# Product Change Notification

## 111136 - 00

<b>Change Notification #:</b>	111136 - 00
<b>Change Title:</b>	<b>Intel PRO/100 M Desktop Adapters, PILA8460MBLK20/PILA8460M (Dayville Retail), Intel PRO/1000 PT Server Adapters, EXPI9400PT/PTBLK/PTG2P20 (Glyndon OEM generic/Retail), Intel 10 Gigabit AT2 Server Adapters, E10G41AT2/AT2G1P5 (Copper Pond Gen 2 OEM generic/Retail), Intel PRO/1000 MT Dual Port Server Adapters, PWLA8492MT/MTBLK5/MTG3P20 (Double Barrow OEM generic/Retail) and Intel PRO/1000 GT Dual Port Server Adapter, PWLA8492GTG1P20 (Double Barrow II LF OEM generic)</b>  <b>PCN 111136-00</b>  <b>Label</b>  <b>OUI block change</b>
<b>Date of Publication:</b>	<b>November 16, 2011</b>

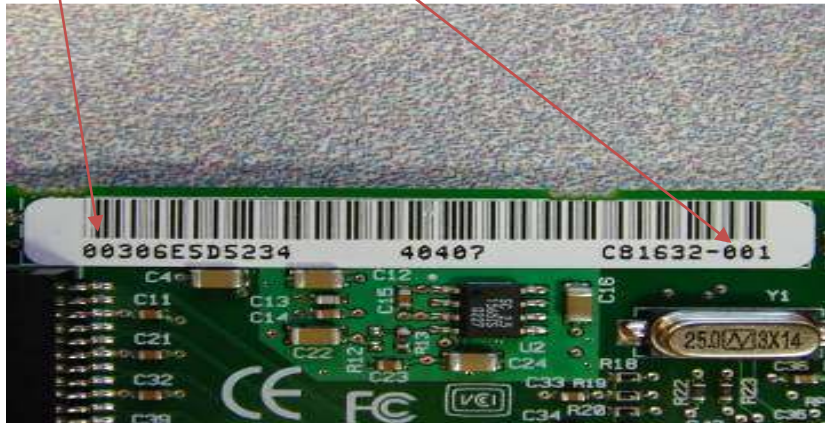
**3n1 label change:** The 3n1 label will change to reflect the new OUI Block number and PBA# dash roll (printed board assembly), as show in the picture below. The 3n1 label is placed on the Front side of the Printed Board. (picture example only)

**OUI Block change:** Past run rates have caused the available blocks of MAC addresses assigned to run out. The OUI Block 00-1B-21 has hit the low water mark, the new OUI Block will be 68-05-CA (Glyndon, Copper Pond Gen 2) and 90-E2-BA (Dayville, Double Barrow, Double Barrow II LF).
